PROJECT: CSC | Cumberland Senior Center
1494 Diamond Hill Road
Cumberland, RI 02864

PROJECT #: 20-5200

This Addendum forms a part of and modifies the bidding requirements and proposed Contract Documents for the subject Project, dated September 24, 2020. Receipt of this addendum shall be acknowledged on the Bid Form.

B1 TYPICAL WINDOW HEAD DETAIL
A502 SCALE: 3" = 1'-0"

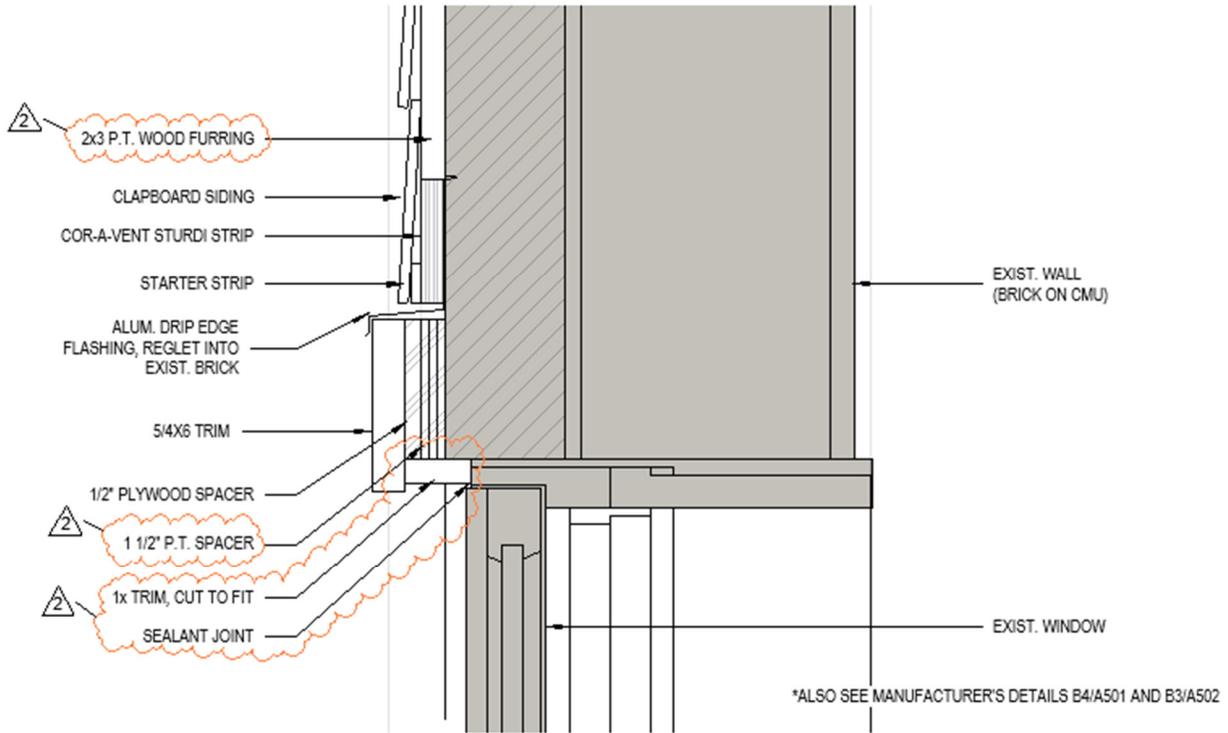
2. A502 – DOOR AND WINDOW DETAILS & SCHEDULES
 - a. Detail B1/A502 – include 1x trim from head trim back to existing window. Seal joint between trim and window. This shall be the same detail at the jambs, minus the $\frac{1}{2}$ " plywood spacer behind the trim and the trim is 5/4x4 vs 5/4x6 as noted on the exterior elevations. See revised detail.

C1 TYPICAL SOFFIT DETAIL
A102 SCALE: 1" = 1'-0"

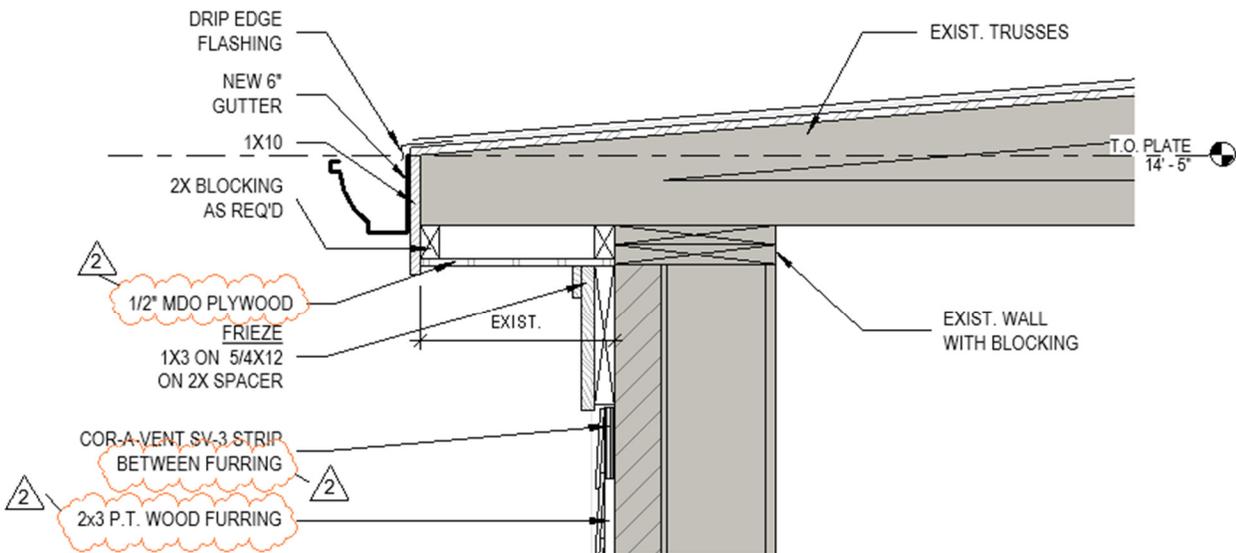
3. A102 – ROOF PLAN & DETAILS
 - a. Detail C1/A102 – Soffit board shall be $\frac{1}{2}$ " MDO plywood.
 - b. The cor-a-vent SV3 strips are to be installed between furring strips to allow for nailing of trim and siding. See revised detail C1/A102.
